# IDT 77211 Errata

Item Number	Short Description
1	Correction to 128K x 32 SRAM memory map
2	Bus Park is not supported with random (mod 1)
3	Limitation in mixing TSRs with and without interrupt generation
4	Early frame de-assertion on latency timer expiration
5	RxSoc assertion before RxEmpty# deassertion or before RxClav assertion causes incorrect operation

### **NICStAR SRAM Memory Map For Using 128k X 32 SRAM**

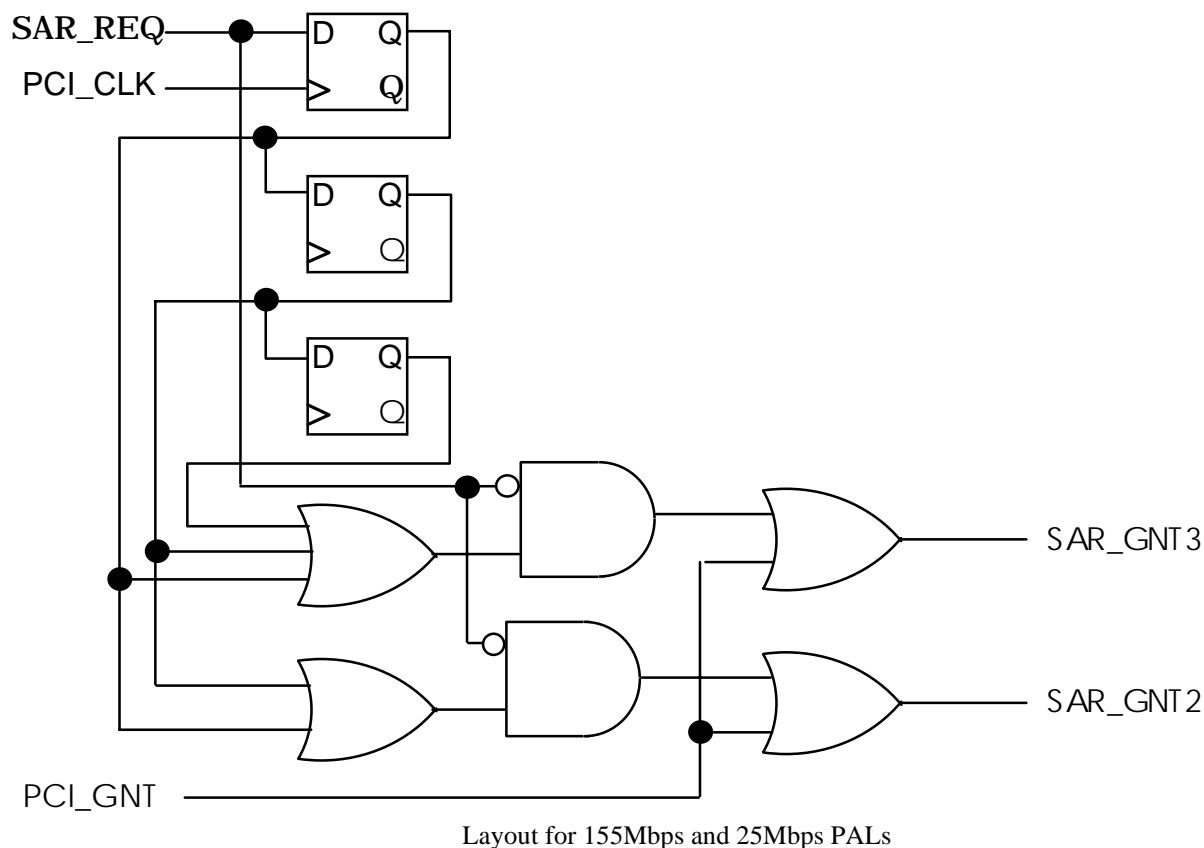
Item	Issue	Current Work Around
1	The memory map for the 128K x 32 memory configuration is incorrect in the 77201 User's Manual	TST and SCD memory space is identical to the 32K x 32 memory configuration.

The 128K x 32 memory configuration limits the TST and SCD region to the same space allocated for the 32K x 32 memory configuration. The 128K x 32 memory configuration does allow for additional Rx connections. The memory map for 128K x 32 memory configuration is altered to show as follows:

Fix: The full address space will be addressable in the 77252 ABR SAR
